# LANDMARKS COMMISSION APPLICATION

Project Address: 138 South Franklin St Aldermanic District: 6

Project Title/Description: Rehab & addition

## Narrative Description of 138 S. Franklin Street

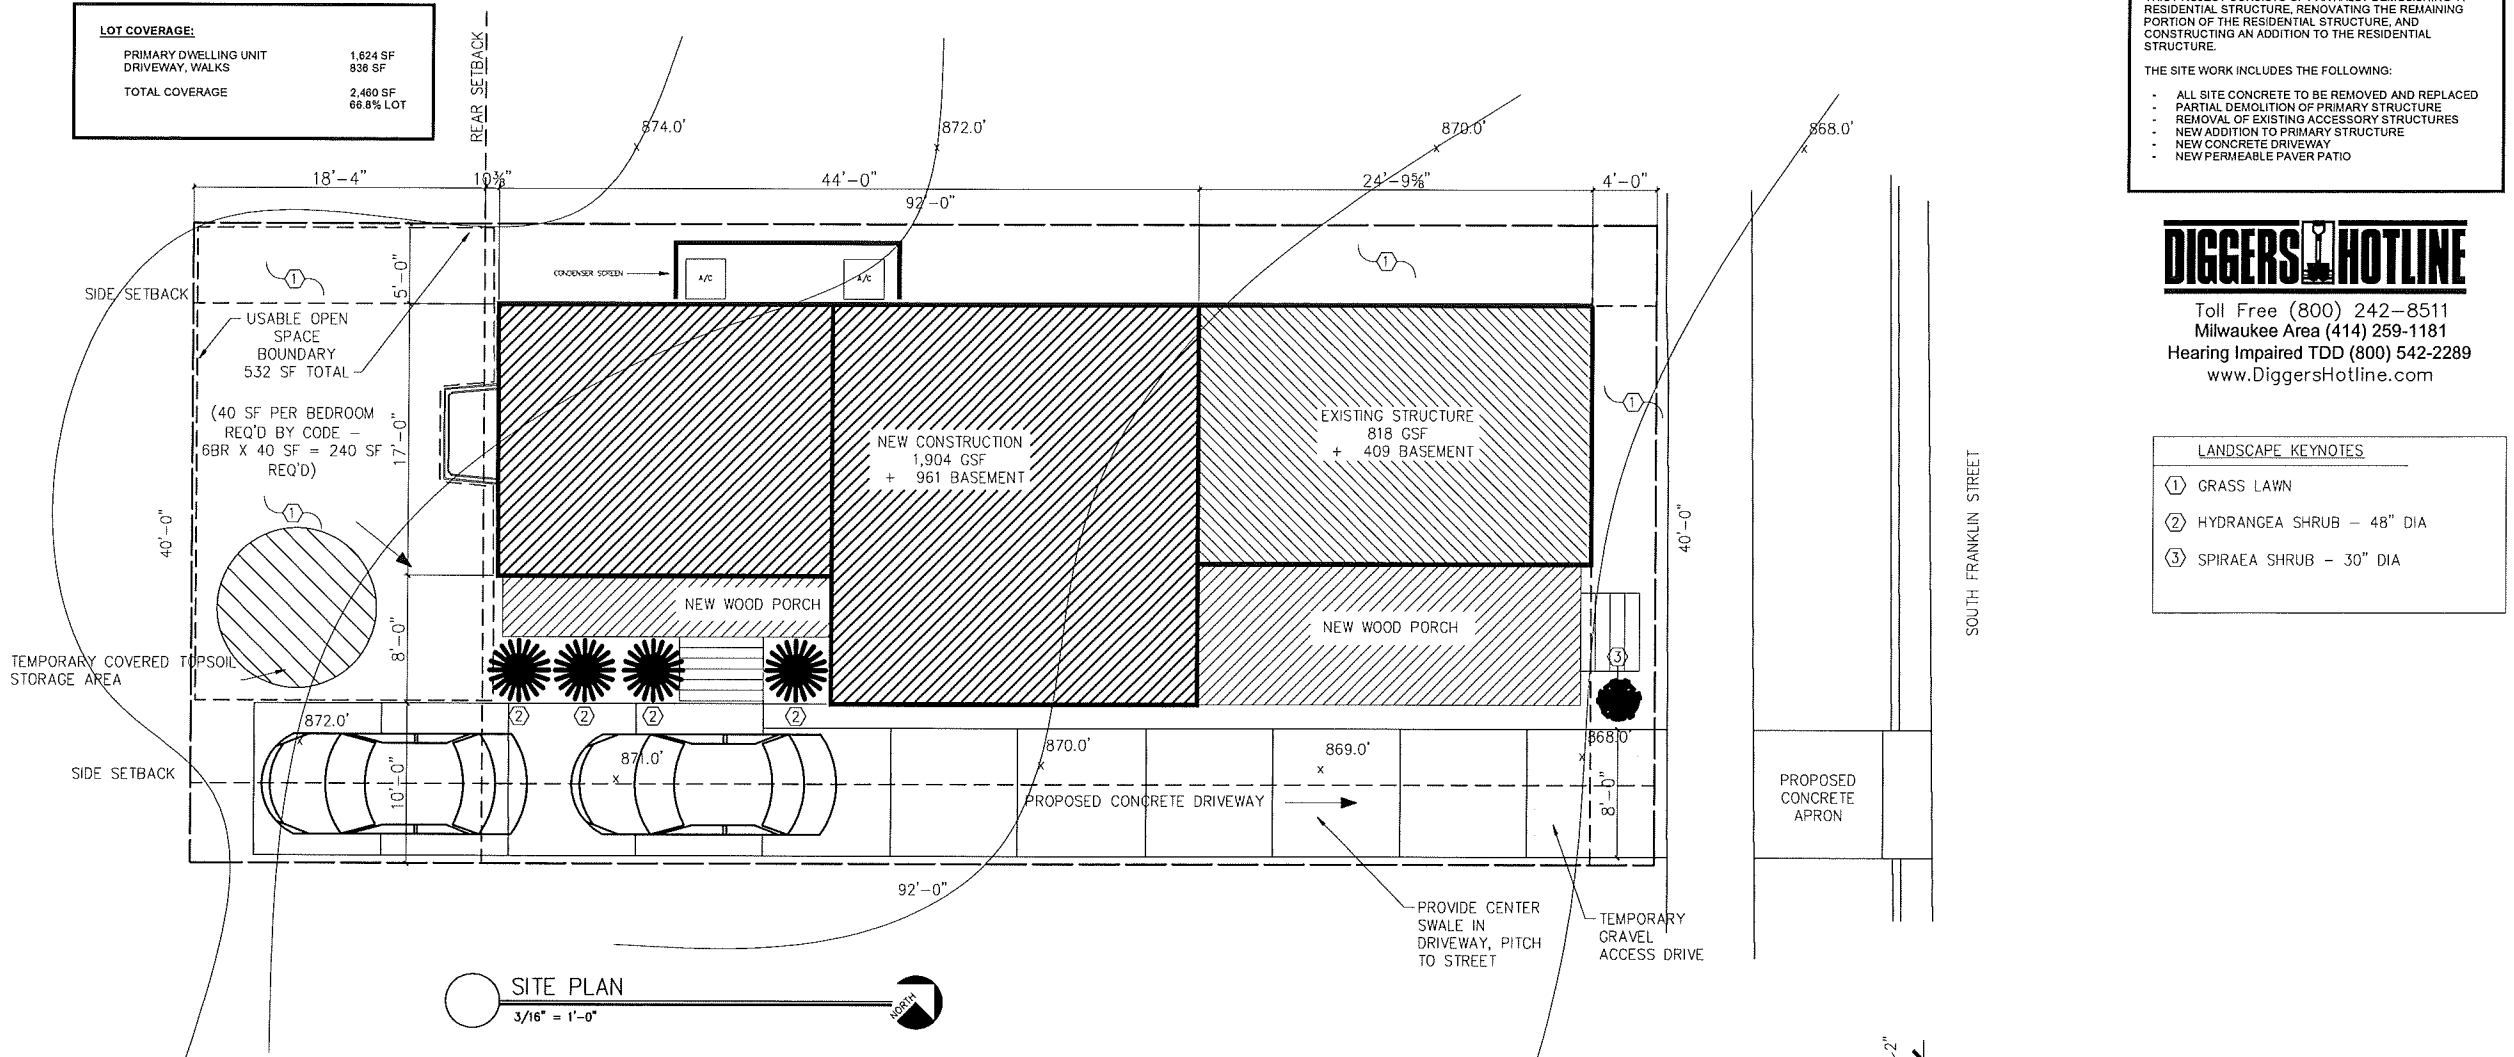
The first change has been window placement. On the south side elevation you can see one window on the first floor moved up to the second floor. That was because there is a staircase that would be going right through the middle of that window, and on the second floor it has a great view from the upstairs kitchen. The windows on the second floor on the north side elevation were filled in, as one blocked where the kitchen would be, and the other one was facing nothing but a wall. Also, bringing up another window to the second floor on the south side supplemented the replacement of the window filled in on the north side.

The second was the changes made to the roof lines/gables on the home. That was done because the way the previous roof line and gables were angled cut a triangle shaped space into the home that would make large amounts of space uninhabitable or with an extremely angled roof.
